Part Change Notice: AX01 Floating Side Connector Shape Change

JAE has changed the shape of the floating side on our AX01 series connectors to improve the yield rate of the insulator. Please see details below.

(1) Change of insulator shape on connector's floating side.

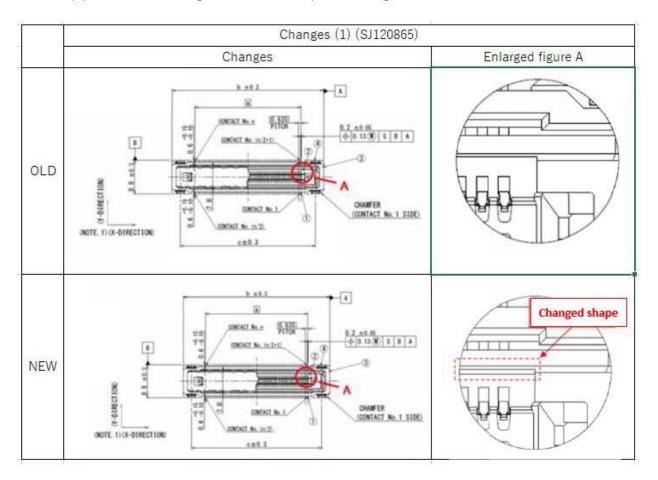
\*Enlarged figure is for explanation purpose only, and it will not to be reflected in the drawing.

Section (1) Continued: Change of insulator shape of floating side connector.

(2) Note deleted from drawing of fixed side connector.

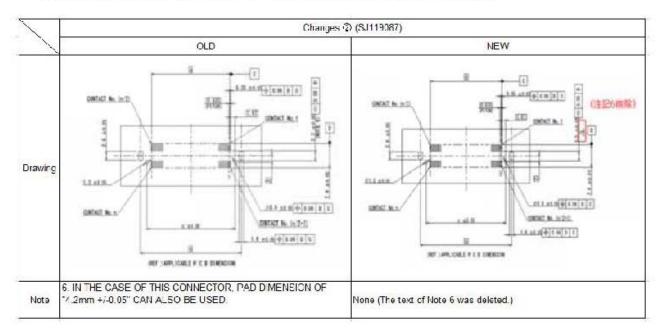
Only the note has been deleted. No physical changes made to the shape.
